PLANNING AND DEVELOPMENT SERVICES STAFF REPORT

For Planning Commission Meeting of May 21, 2013

**SUBJECT: 414 Main Rezoning and Site Plan
Project Nos. Z13-004 and SP13-008**

**401 N. Fourth Avenue Rezoning and Site Plan
Project Nos. Z13-005 and SP13-009**

TITLE
LANDSCAPE PLAN

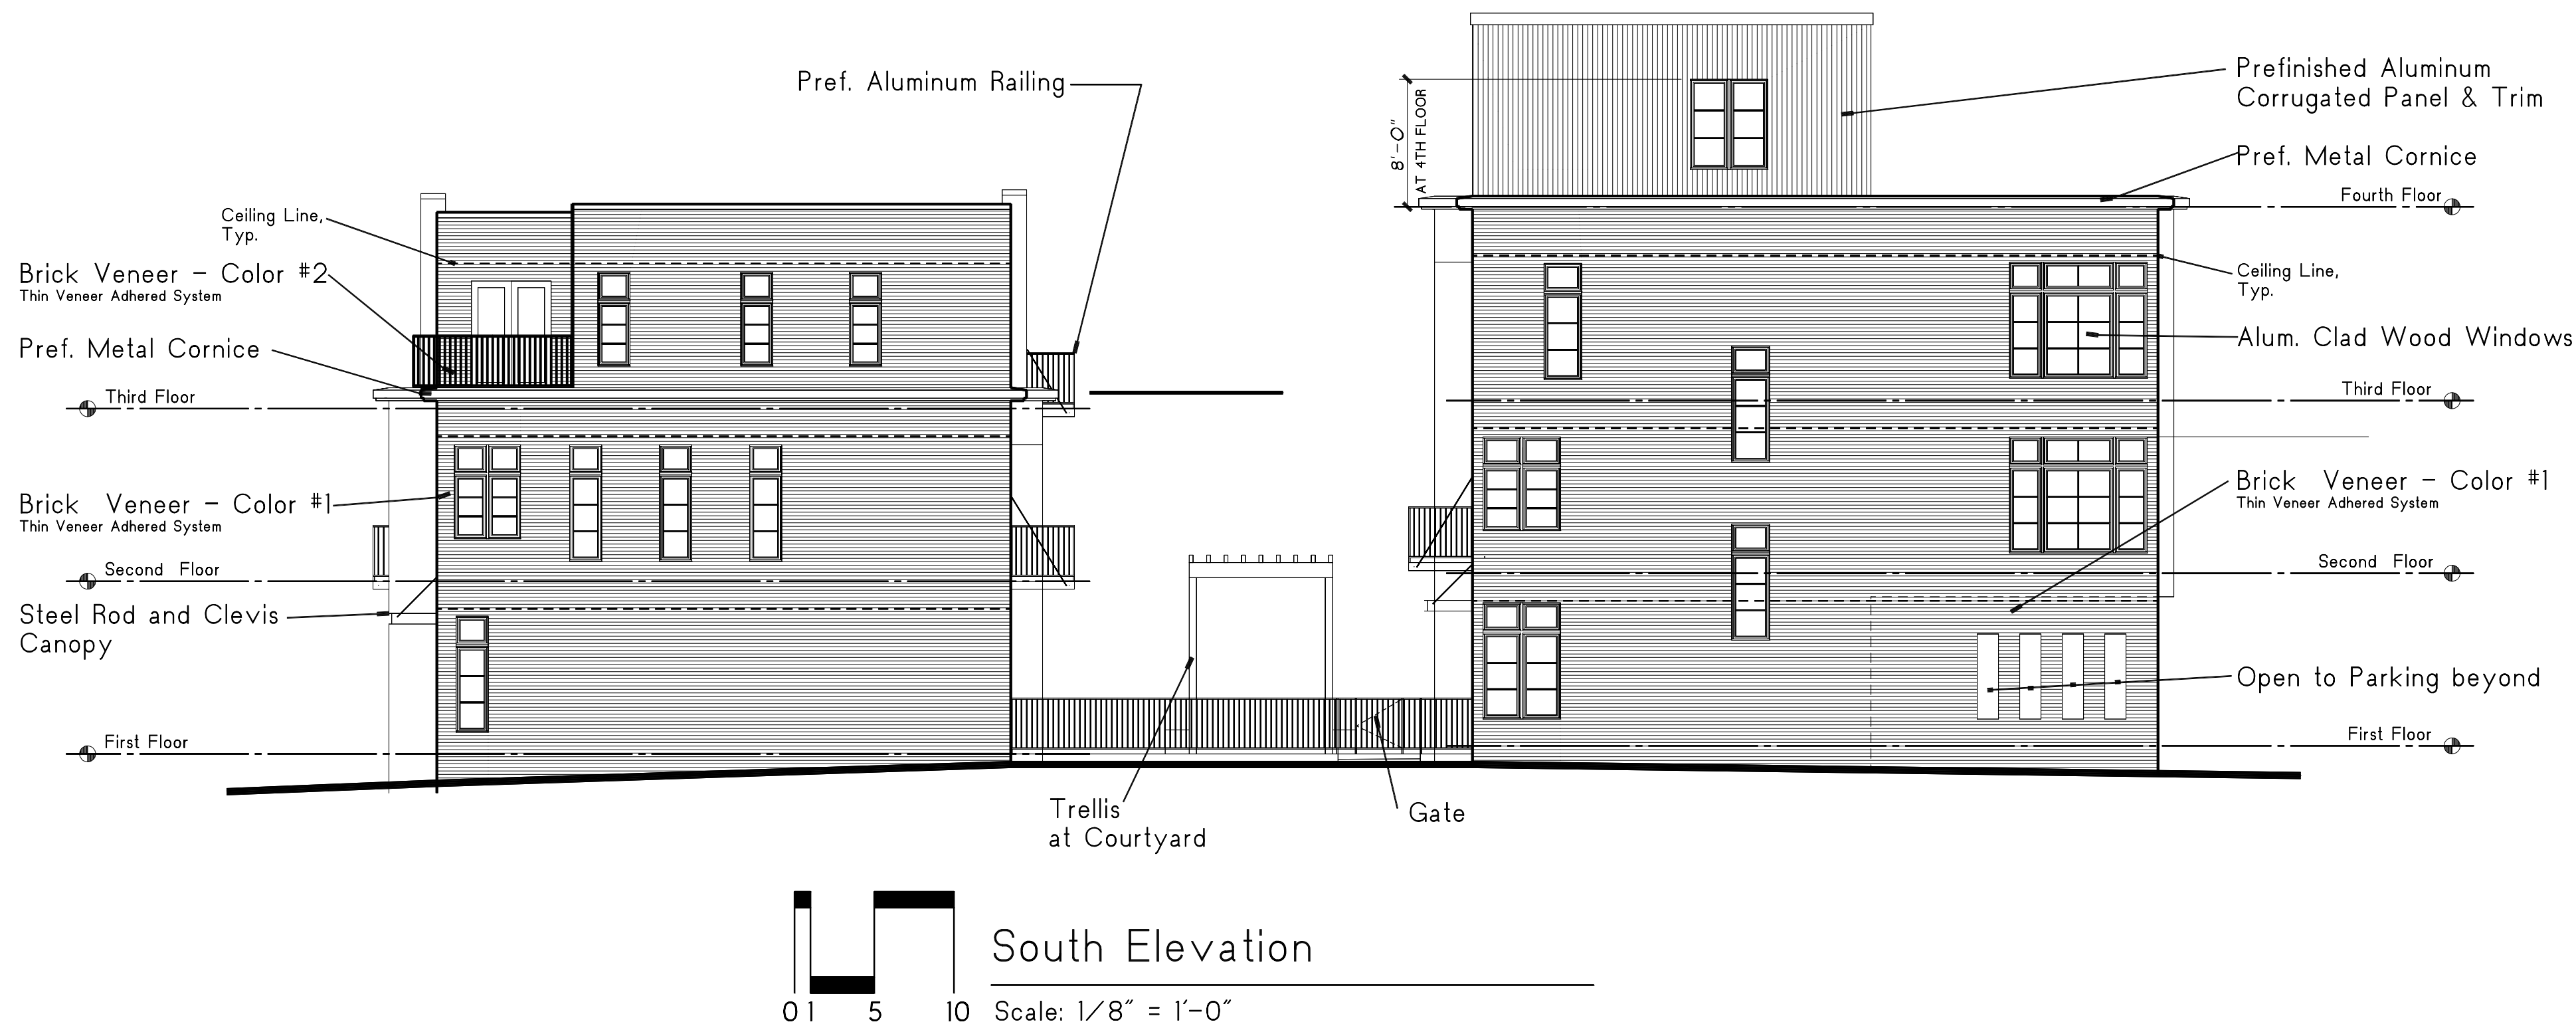
The petitioner has requested a Chapter 62 Landscape Modification to allow the required interior landscape islands to be provided as one continuous landscape bed along the entire north side of the surface parking lot, rather than as a few islands projecting into the parking lot.

The petitioner is seeking a modification of Section 5:602(2) Interior Landscape Islands. This section requires interior landscape islands to be provided in vehicular use areas, and specifies the minimum size in square feet, minimum dimensions of any one island, design and placement of islands, number of trees in each island, and storm water management functions in some cases. The petitioner is seeking a modification of one aspect of Section 5:602(2), specifically a modification that will allow landscape areas outside the perimeter of the vehicular use area to count toward satisfying the interior landscape island requirement. Rather than providing several islands projecting into the vehicular use area, the petitioner is proposing to provide one continuous area along the length of the north side of the vehicular use area. The proposed design meets the requirements for minimum size, number of trees and storm water management functions.

The Natural Resources and Urban Forestry Coordinator agrees that the modification is consistent with the intent of the Chapter, has been shown on the site plan, and is associated with a site located in a special parking district, per Chapter 62, Section 5:608(2)(a), (b), and (c)(i).

Forestry and Natural Resources – Staff supports the petitioner’s Chapter 62 Landscape Modification request. Staff also finds the alternative analysis shows the proposed disturbance to the landmark tree to be the minimum necessary for a reasonable development.

A-6

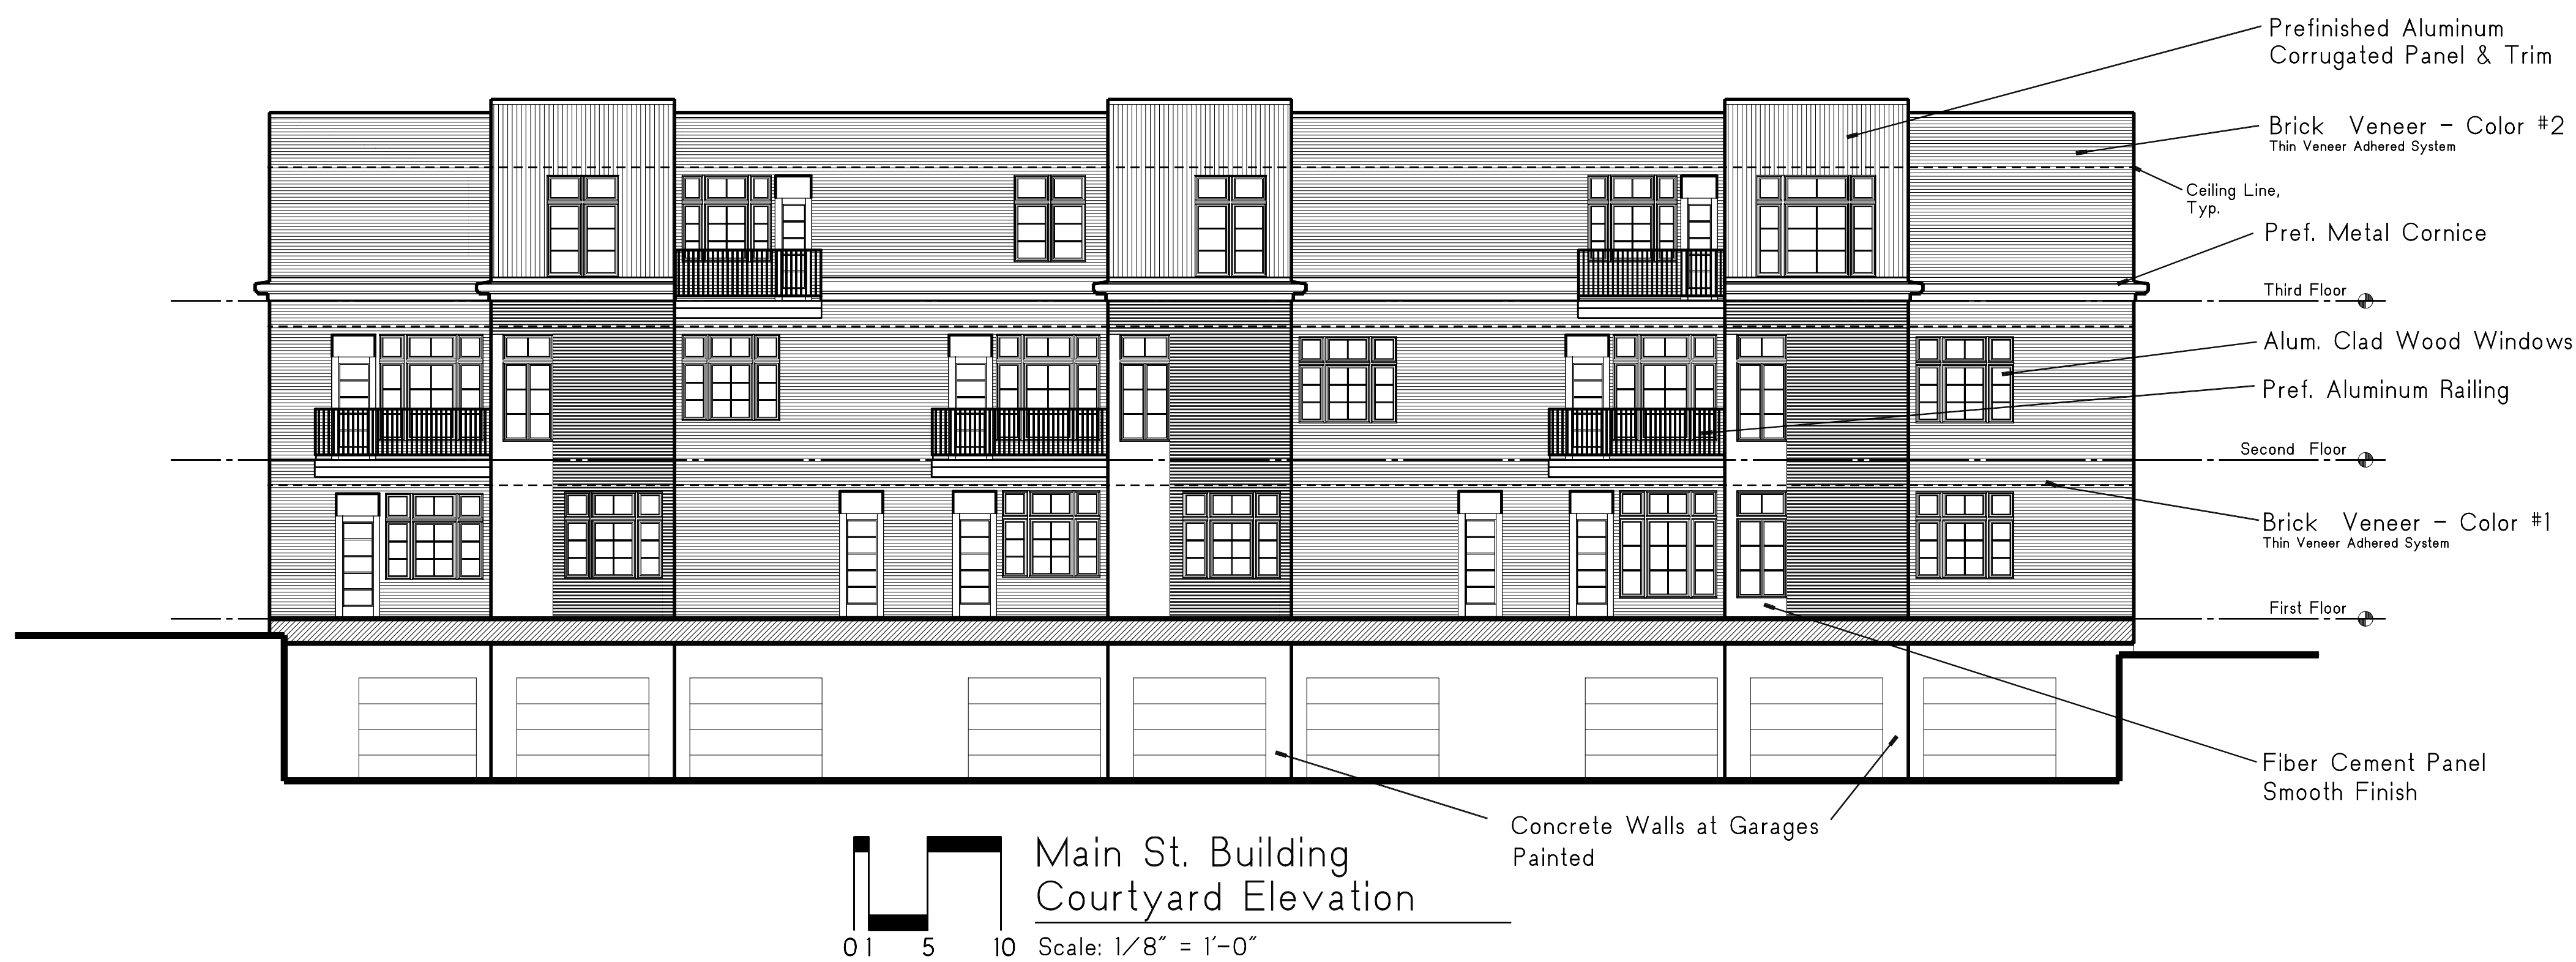
- The Alley building (east tower) is not tall enough to warrant a complete change for the top level material. It currently reads as mechanical unit screening rather than living space.
- The end of the towers could be further softened with architectural detailing and/or plant materials.
- The two double-wide garage doors dominate the street level façade of 401 N. Fourth Avenue. Many other façade and landscape treatments would be preferable.

However, the Board raised three points for the design team to further consider. First, regarding the Alley building penthouses, the building is not tall enough to warrant a complete change for the top level. The change of materials to a metal screen, particularly the "putty" color, read more like mechanical unit screening than penthouses that are part of a residential unit. The Board felt that feature would not be

read correctly from the street level and suggested considering using the same materials as the lower portion of the building, changing the color of the metal material, adding more doors and windows to the penthouses, or some combination of those suggestions.

1. To alleviate the concern that the exterior of the 414 Main penthouse appeared to be mechanical unit screening, the floor was expanded in size and numerous doors and windows were added. The final color has yet to be determined, but the choice of color will be in concert with the rest of the building.
2. To soften the south end of the 414 Main building, openings in the wall to the parking area [carports] have been added. In addition, climbing vines will be planted at the base of the walls.
3. Two double garaged doors on the east side of the duplex building at 401 N. Fourth Avenue building have been replaced with two single garage doors on the east side and two single garage doors on the west side, as recommended by the Design Review Board. Additional landscaping has been added to the east side of the building.

1. To alleviate the concern that the exterior of the floor units appeared to be mechanical unit screening, the floor was expanded, the floor expanded in size and numerous doors and windows were added. The final color has yet to be determined but the choice of color will be in concert with the rest of the building.
2. To soften the south end of the building, openings in the wall to the parking area have been added. In addition, climbing vines will be planted at the base of the walls.
